TECHNICAL SERVICE BULLETIN

Bulletin Number: **SLI-15-01**
Model Year(s): **2015**

SUBJECT: 2015 Slingshot / Slingshot SL – Roll Hoop Replacement

SERVICE BULLETIN COMPLETION DECAL:

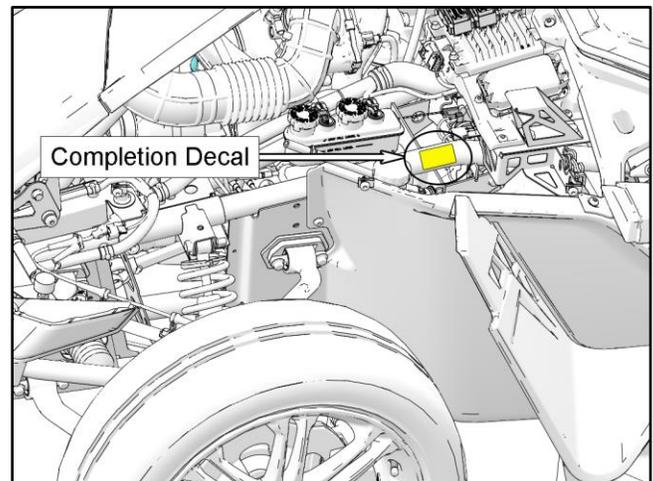
A Service Bulletin Completion Decal (PN 7170107) must be completed for this bulletin repair. Place the decal on the left side frame tube, near the brake master cylinder (as shown). If you require more decals, order them through normal Polaris parts ordering channels.

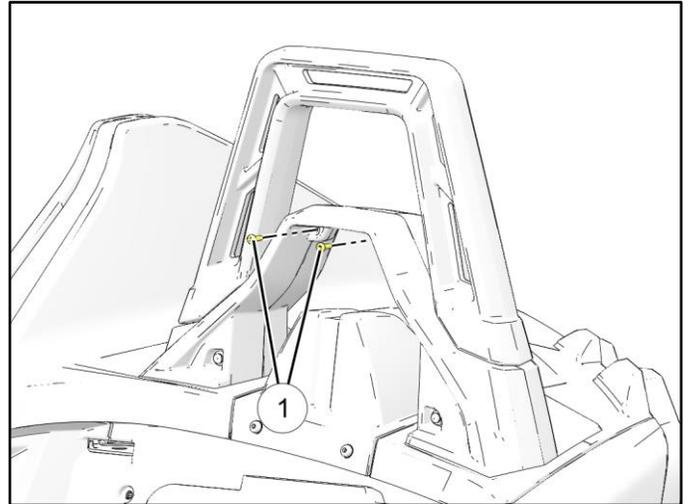
2. Move driver seatback to the forward position.
3. Using a T25 Torx driver, remove the upper roll hoop cover screws ①.

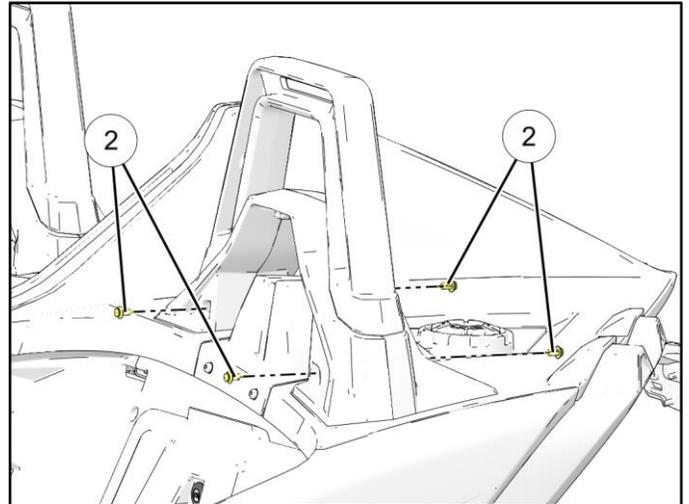
4. Using a T40 Torx driver, remove the lower roll hoop cover screws ②.

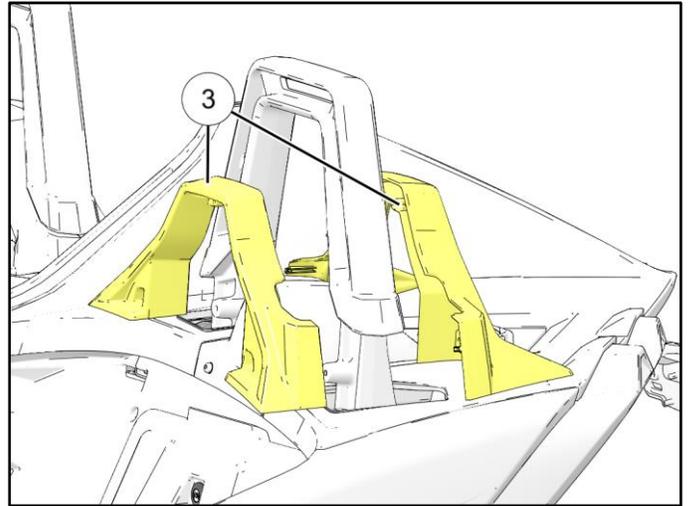
5. Carefully remove roll hoop covers ③ and store in a safe place to avoid damaging painted surfaces.

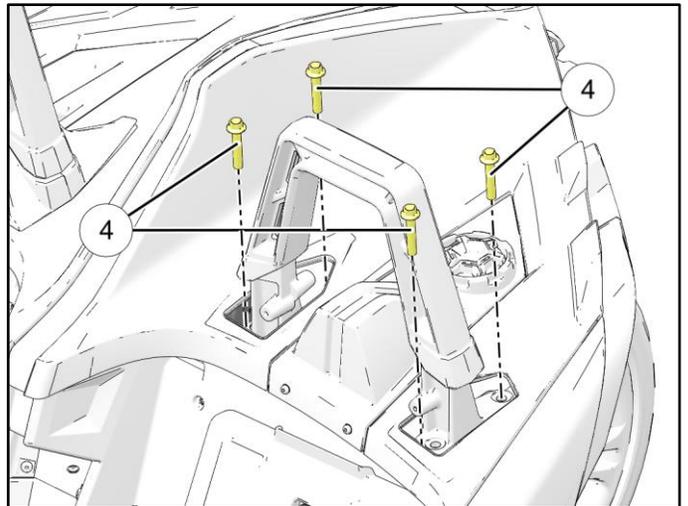
6. Using a 16mm socket, remove the bolts ④ securing the roll hoops to the vehicle and discard.

7. Remove the roll hoop ⑤ and retain so that it can be returned to Polaris.

8. Install the new roll hoop and torque fasteners to specification using a crisscross pattern.

TORQUE:
Roll Hoop Bolts: **60 ft-lbs (81.3 Nm)**
